13 November 2021

Verification of the authorised Rietkloof wind energy facility (WEF) turbine layout, in relation to the bat sensitivity map and impacts on bats.

Figure 1: Bat sensitivity map of the Rietkloof site with proposed turbine layout.

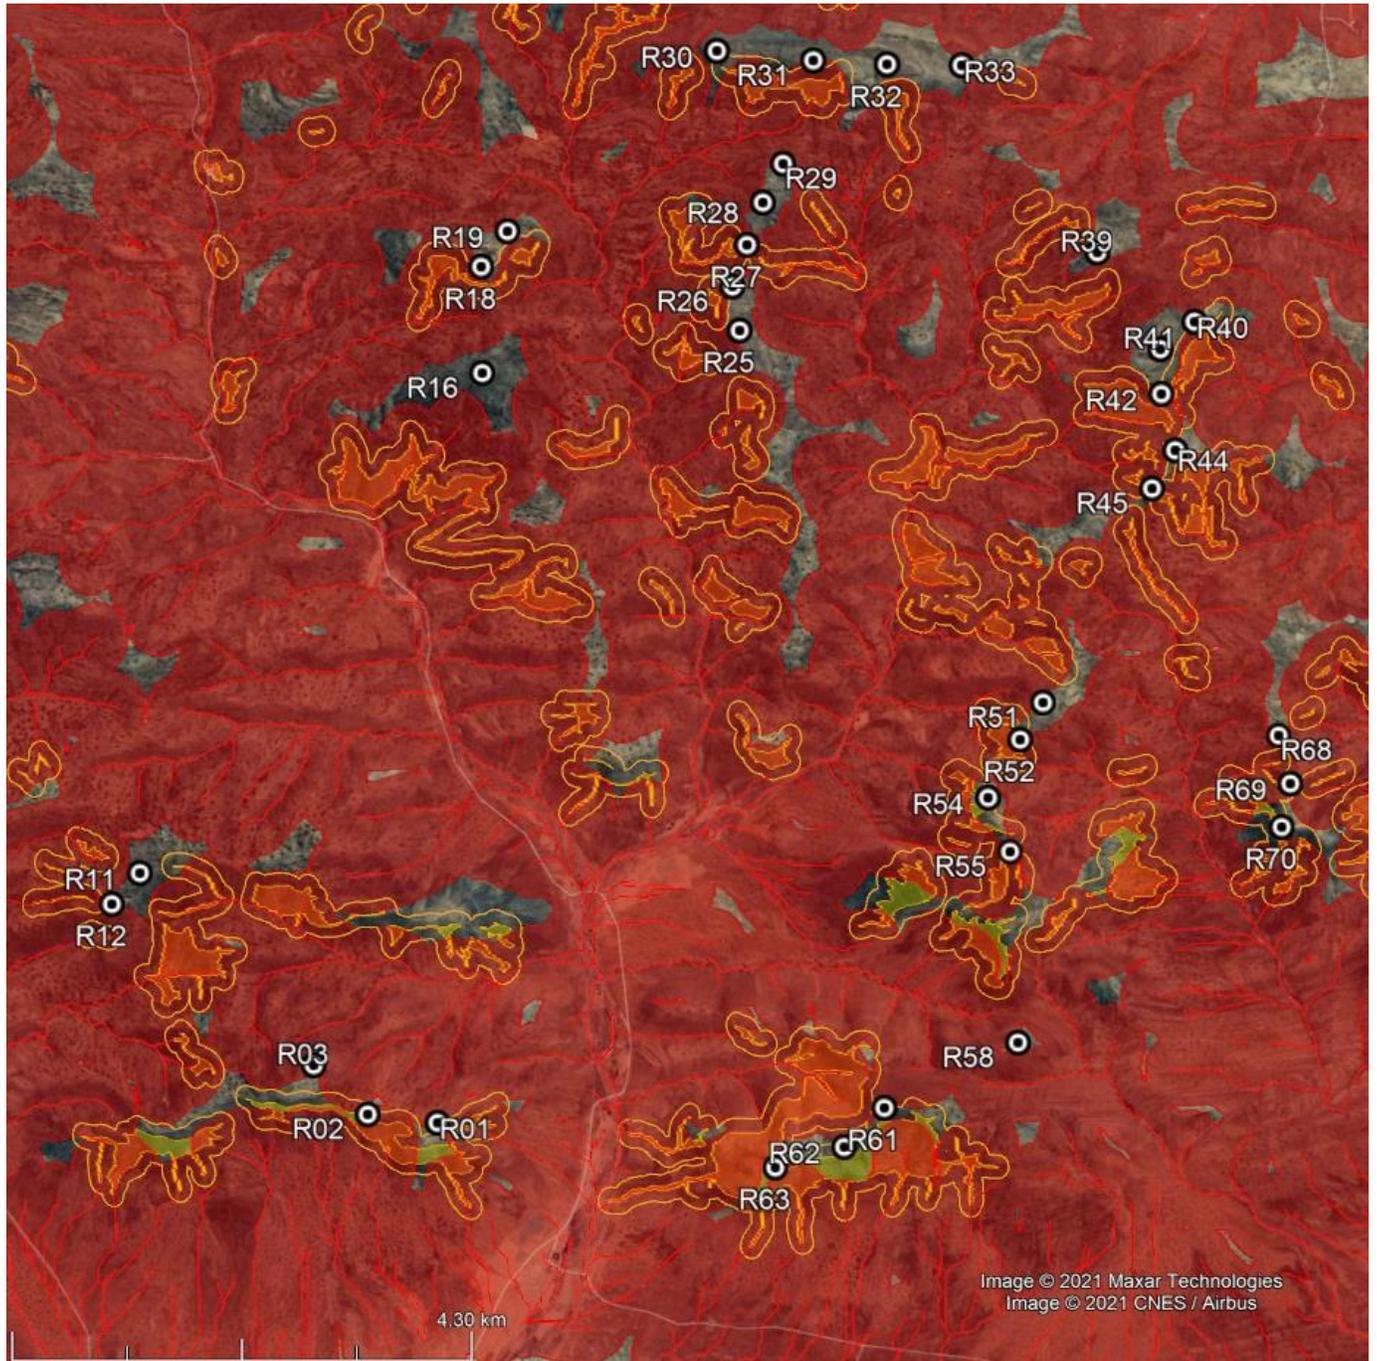
A site visit was conducted on 13 September 2021 by Animalia Consultants (Pty) Ltd to verify the turbine layout in relation to the approved bat sensitivity map. The proposed turbine layout respects the bat sensitivity map as was applicable during the preconstruction guidelines that was in use during the EIA assessment and subsequent amendments (**Figure 1**). It also respects the current guideline criteria which requires turbine blade length to be outside the high sensitivity buffers, except for Turbines R27, R37 and R49.

depressionless DEM. Next, the flow accumulation is calculated meaning how much water can accumulate in one cell (in m³). Thresholds of 50k, 75k and 100k were considered and 75k was determined to be the most accurate threshold with the least amount of data 'noise' (**Figure 1**).

Figure 2: Indication of Turbine 27 in relation to the bat sensitivity buffers (without applying 3D model). Turbine 27 is still inside the high sensitive buffer when applying the 3D model

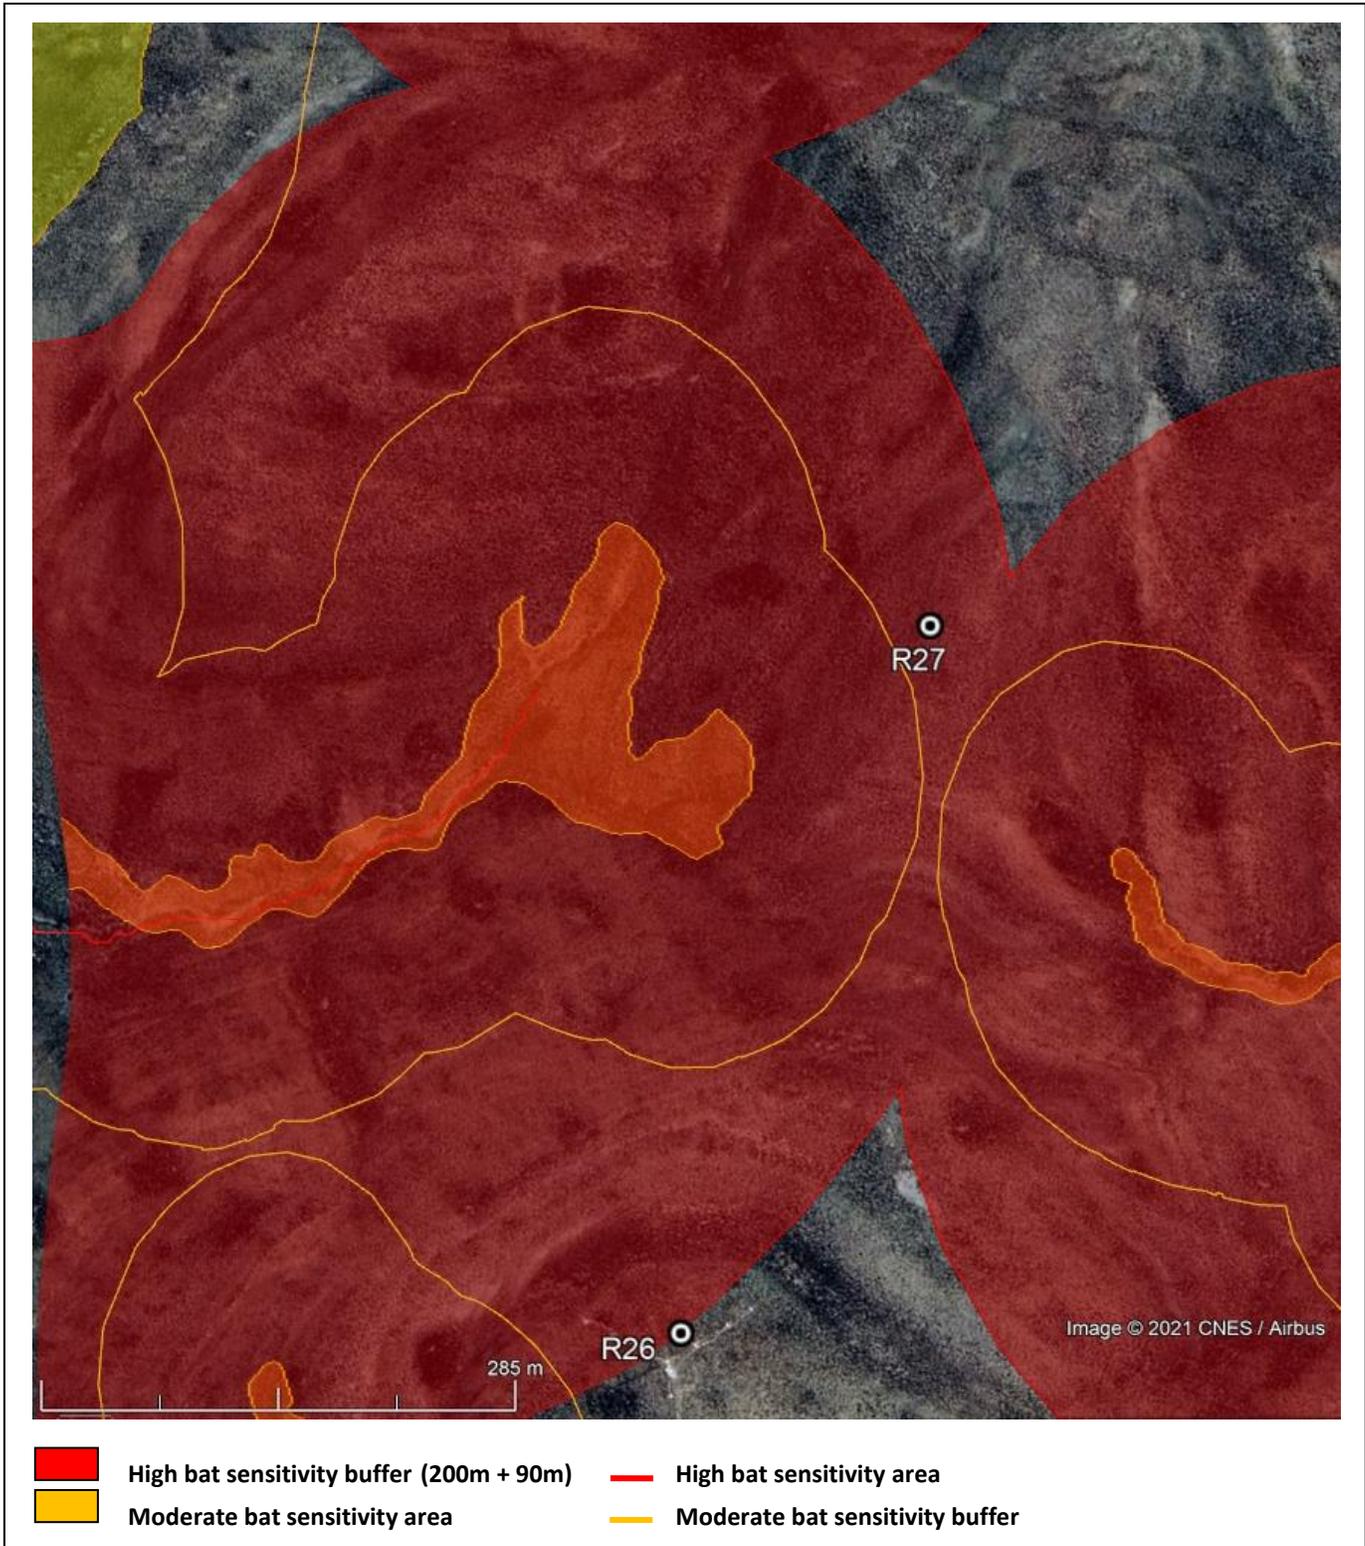
On a flat surface the distance from a high sensitivity must be 200m, which constitutes the high sensitivity buffer. This includes all parts of a turbine such as the turbine blades, and is in line with the MacEwan, et al. (2020) Preconstruction Guidelines. Therefore, based on a rotor diameter of 180m (blade length of 90m), the turbine base position must be 290m or more from any high bat sensitivities and 90m from high sensitivity buffers. However, in this case the actual bat sensitivities are at a lower elevation in valleys and the turbines are proposed on the ridges. In cases where the turbine base was closer than 90m to the high sensitivity buffer, a formula was applied to consider the hub height of 125m, 90m blade length and difference in elevation of turbine base and sensitivity. In order to calculate the distance of the base to the buffer required for maintaining a minimum of 200m from a blade tip to an actual sensitivity. This formula was only required for Turbine R27 since its blades are intruding into the high bat sensitivity buffers to the East (**Figure 2**).

When considering a 90m blade length, based on above calculation considering the difference in elevation between the bat sensitivity and the turbine base position, Turbines R27, R37 and R49 base centre points should be moved to be outside the high bat sensitivity buffer. All other turbines proposed can remain in the currently authorised positions. The significance ratings of the original impacts identified will not change as a result of the amendments.

In summary, the proposed layout is acceptable from a bat sensitivity perspective if all conditions of the EA are adhered to, an operational bat impact monitoring study is conducted for a minimum of 2 years, and Turbines R27, R37 and R49 base centre points should be moved to be outside the high bat sensitivity buffer.
